**Correspondence Between  
Staff and Applicant  
Approval Letter**

**From:** Matthew Hinchcliffe <mhinchcliffe@arcv.com>  
**Sent:** Thursday, December 01, 2016 11:17 AM  
**To:** McClay, Doris  
**Subject:** Panera - Scottsdale, AZ - RTU Screening Material

Attn: Doris McClay  
Planner Department  
City of Scottsdale

The Planning & Development Services Division has completed the review of the above referenced development application submitted on 8/8/16. The following **1<sup>st</sup> Review Comments** represent the review performed by our team, and is intended to provide you with guidance for compliance with city codes, policies, and guidelines related to this application.

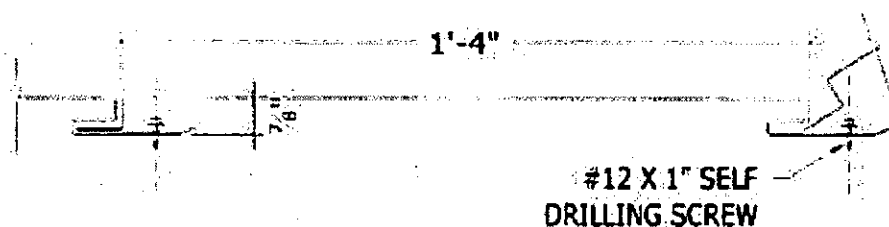
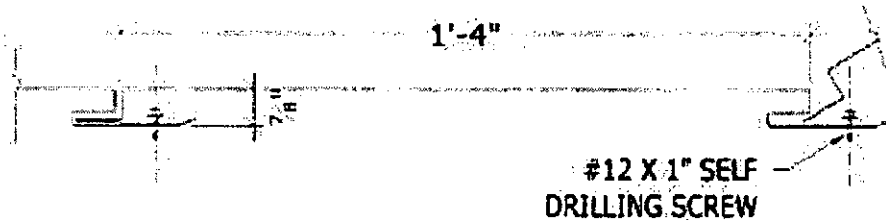
Could you have a look at the attached image to see if this finish would be acceptable? Again color would be match our building.

Will this roof screening be acceptable?  
Doris

Yes.
